COMMENTS AND RESPONSE REPORT (EIA PHASE)

**Proposed “PERSEUS - KRONOS” 765kV Transmission Powerline & Substations Upgrades,
Northern Cape and Free State Provinces, DEA Ref: 14/12/16/3/3/2/438**

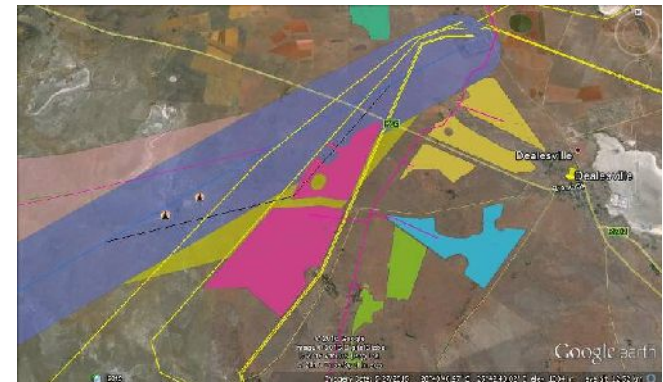
Mainstream Renewable Power has submitted a suite of solar projects in this area for approval to the Department of Environmental Affairs, one of which is directly impacted by the proposed routing of the 765kV line. The Leliehoek Solar facility, DEA Ref No. 14/12/16/3/6/2/728 is anticipated to receive environmental authorisation within the next few weeks and forms part of a suite of 11 solar facilities which have been submitted. For ease of reference please see the attached shape files detailing the projects in relation to the proposed power line routing.

Thank you for bringing the affected solar developments to our attention and for providing the kmz files. As indicated in the attached Google Earth image, portion of the “pink area” solar facility is traversed by Deviation 1A, which is the black line within the yellow 2km corridor (1km on either side of the black line).

A suggestion is to possibly follow the blue corridor. Do you

I&AP	Concerns & Queries	Date	Response from Mokgope / Eskom
	<p>In light of the above we request that the proposed facilities be accommodated in the routing proposed in the FEIR for the 765kV line.</p> <p>Date: 31-05-16. Mercia.Grimbeek@mainstreamrp.com</p> <p>Agreed, please move into the blue shaded area. The required buffer from the solar facility is 50m. Should you have any further questions please do not hesitate to contact me.</p>		<p>agree to this regard?</p> <p>What is the required buffer distance between your solar facility fence and Eskom servitude edge line? We would like to know how far we may shift the proposed line away from the solar facility.</p> <p>Please advice as soon as possible to start the deviations of the proposed power line. Thank you. EAP: Date: 31-05-16.</p> <p>Thank you for your response. Eskom will be notified to this regard. We will send you an update of the amended report once finalised. EAP: Date: 06-03-17.</p> <p>Herewith a portion of the finalised map, illustrating your area. It does not include the initial Deviation 1A that affected your development.</p>
